Response to reviewer' comments
On the manuscript **nhess-2020-132**
revised for publication in
NHESS

First, we wish to thank the reviewer for their valuable insights. below our *response (in italics)* to the reviewer's raised points.

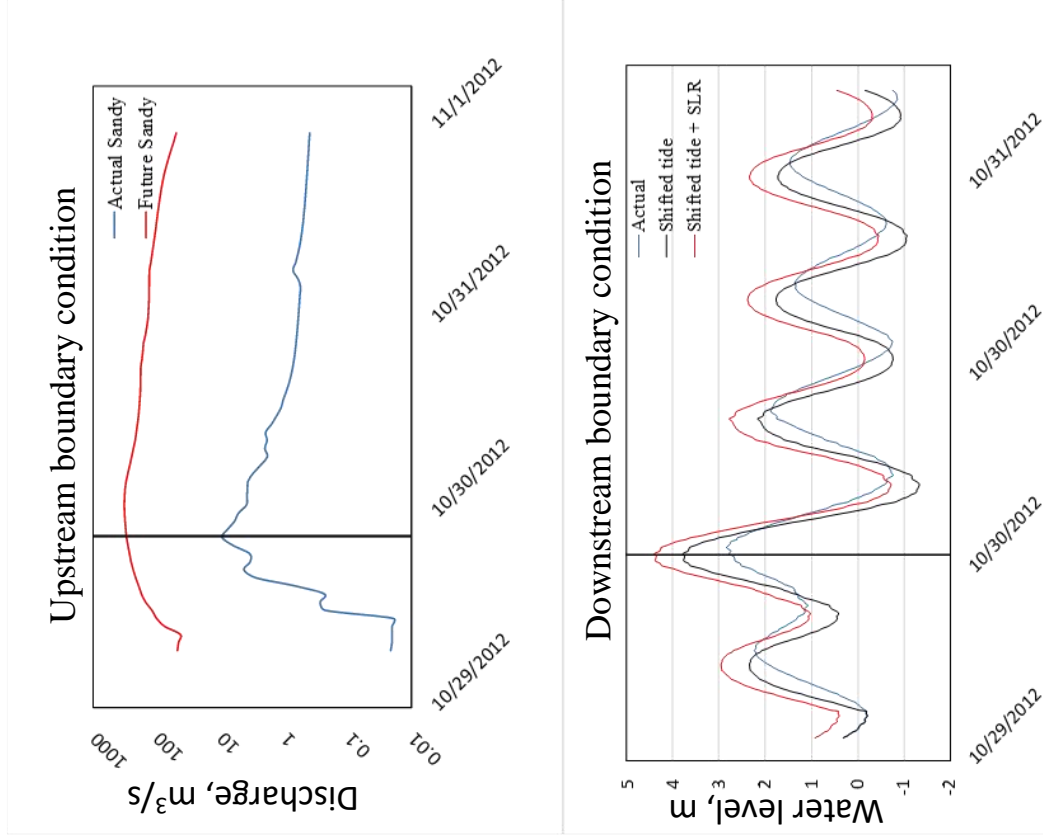
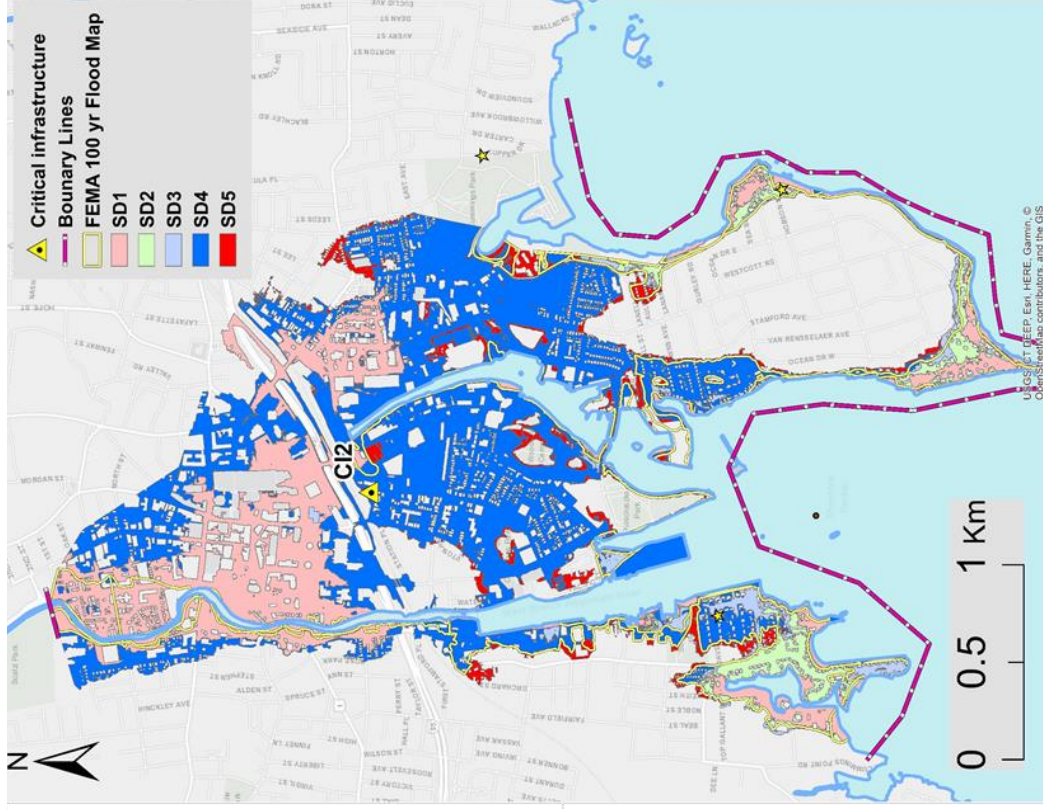
- Figure 3 and throughout the text: put the superscript 3 in "m³/s".

- Figure 3: "Stream flow at upstream" => "Upstream boundary condition"; "Total Water Level at Downstream" => "Downstream boundary condition"

- Caption of Figure 3: “firhg-hand panel” should read “right-hand panel”.
We fixed it. Please see the response above.

We have fixed it. Please see the next response.

We have made changes according to reviewer's suggestions. Please see below-
